**CITY OF EL PASO, TEXAS
AGENDA ITEM
DEPARTMENT HEAD'S SUMMARY FORM**

CITY OF EL PASO CONSTRUCTION CHANGE ORDER

CONSTRUCTION CHANGE ORDER NO.: **8**

PROJECT: **Dyer Corridor Rapid Transit System**

Figure 1 – Configuration of 600-watt Power Supplies

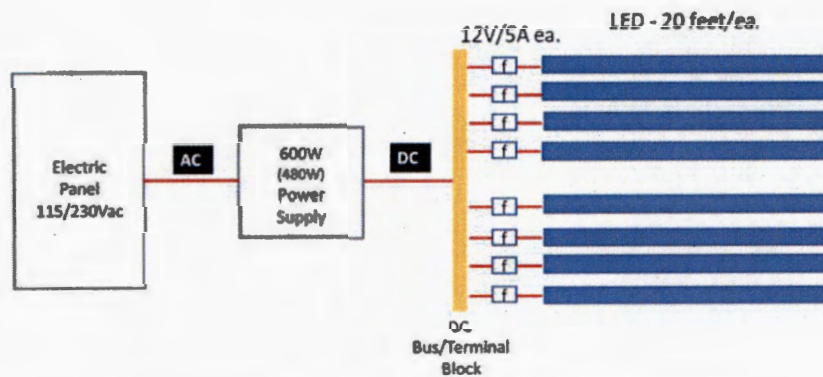
As an alternative and due to space limitations, the use of 600-watt power supplies instead of the smaller 60-watt drivers may prove to be advantageous in terms of size, efficiency and installation costs. Going with the larger power supplies can reduce the total number of individual units needed, by close to a factor of ten (maintaining a comparable cost/watt), and with it, the overall real-estate and heat dissipation requirements. This may also positively affect the size and number of the heat extraction fans in the final design. One 600-

watt power supply driven at 80% of its capacity could drive eight separate circuits of 20 ft LEDs strips. In addition, the efficiency of a 600-watt power supply is normally higher than 90% under certain conditions, in contrasts to 86% for the smaller 60-watt drives. A typical profile of the 600 -watt power supply is 11" x 6" (see spec for Mean-Well model# HLG-600H-12) whereas, eight smaller MaxBrite 60 W drives will require an approximate area of 17" x 6", not including the required space in between each unit for convection cooling purposes.

The total required real-estate can increase to 19" x 12" or larger to drive 480W of LEDs. Given the nature of larger demand capacity power supplies, which are not constrained to a minimum power output, a recommendation could be to "fuse" each individual LED circuit and to limit their length size to 180 LEDs or 45 W each. See Figure 1 below:

The above are recommendations only and JFC is directed to proceed with the shop drawings, wiring diagram, and procurement of a working system as displayed in the mockup presentation approved by the end user, Sun Metro. Furthermore, JFC has agreed to exhaust any canopy LED excess linear footage quantities up to the plan quantity, into the pylon LED installation.
